**RE: Speedway – Juan Tabo
 2912 Juan Tabo Blvd. NE
 Grading and Drainage Plan
 Engineer's Stamp Date: No Date
 Hydrology File: H22D041**

Based upon the information provided in your submittal received 03/09/2021, the Grading & Drainage Plan **is not** approved for Building Permit and action by the DRB for platting. The following comments need to be addressed for approval of the above referenced project:

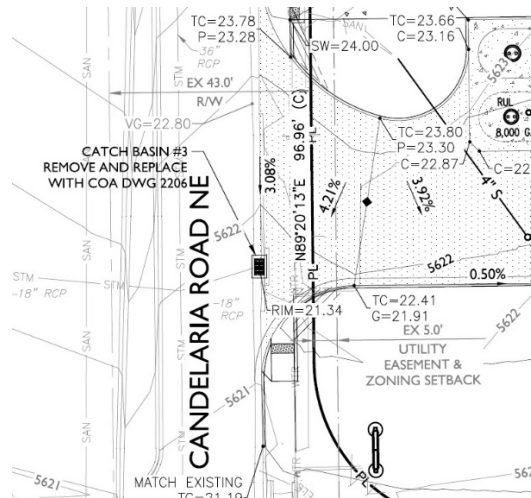
5. On Candelaria, the proposed drive has an existing bus stop in the middle that will need to be relocated. (See Photo below). Please contact City of Albuquerque Transit Department customer service at (505) 243-7433. They should be able to direct you to the person in-charge of bus stop relocations.

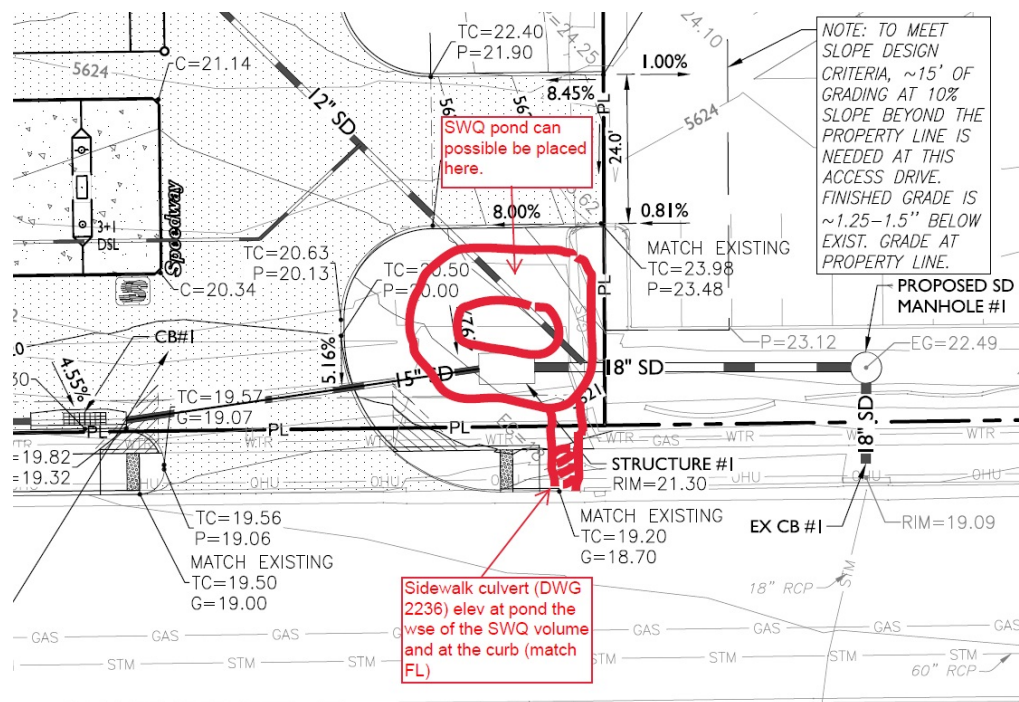
6. Please provide the drainage calculations for the private drainage pipe system.
7. The on-site drainage system is private but you have called out CoA standard drawings for the structures. (see below). Since this is private, the City does allow you to use HDPE pipe and inlets to save on construction cost. Please insure that the correct inlets and pipe sizes is all that you need. (see item #6).
